Dharma Cloud Foundation

App. 1-06-022-A1
September 7, 2007 ;
Item 10a. Ten Mile Bridge
Railing

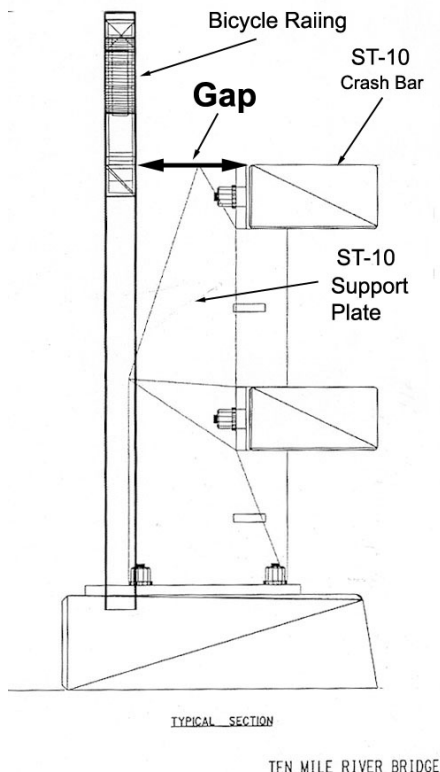
The Caltrans design for the combination automobile/bicycle railing creates a significant hazard for cyclists. An entirely separate bicycle railing is placed at the **back** of the supporting plates for the automobile barrier (the ST-10). In consequence the bicycle railing is 15" behind the front of the ST-10 crash bar, and there is a horizontal gap of about 7 inches between the back of the crash bar and the bicycle railing.

The gap is unnoticeable in the photo simulations provided to the Commission in Exhibit 1 of the amendment application. However, the gap shows clearly in the cross section of the railing in Exhibit 2

of the amendment (reproduced here). I myself was unaware of the significant setback of the bicycle railing until I saw the permit application and its Exhibit 2.

A cyclist who went over the lower, 32-inch high automobile barrier could easily have an arm, shoulder, leg, knee, or shoe go into the gap between the automobile crash bar and the bicycle rail. If he or she had the misfortune of then colliding with one of the sharply angled support plates of the ST-10, a serious injury could well occur.

Condition: The design of the railing proposed for the inland side of Ten Mile Bridge shall be modified 1) to eliminate the horizontal gap between the back of the automobile crash bar and the lower bar of the bicycle railing and 2) to integrate the bicycle railing and the ST-10.

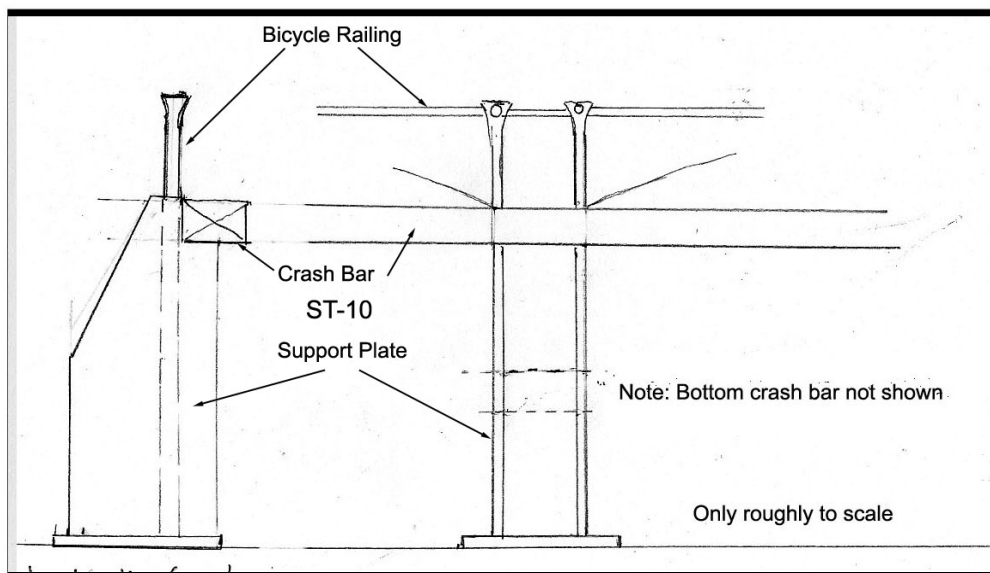
The bicycle railing is 15" behind the front of the ST-10 crash bar, which will look peculiar to motorists and, especially, cyclists. Both will see the gap between the back of the ST-10 and the bicycle barrier. Because of its placement, the bicycle rail will look like an add-on rather than an integrated part of the overall rail design. This defeats one of the design goals for the railing system.

Placing the bicycle railing behind the ST-10 support plates also creates another problem. The pedestrian and bicycle railings have graceful, fairly wide twin support posts. These are quite elegant on their own, but placing them behind the ST-10 support plates brings them into conflict with the design of the ST-10.

One of the aesthetic strengths of the ST-10 is the use of the paired "thin" vertical supports instead of thick "posts." The posts of the bicycle rail are thick rather than thin. When placed behind the ST-10, these posts essentially fill the opening between the paired thin supports of the ST-1

The obvious solution to all of the problems with the present design is to integrate the bicycle railing into the ST-10. This could be done by joining the bottom bar of the bicycle railing to the back of the top crash bar of the ST-10 and modifying the railing posts so that they don't fill the space between the two support plates. A rough sketch of this concept is below.

With the alternative design, there would no longer be a gap, nor would the bicycle support posts fill up the space between the support plates of the ST-10.
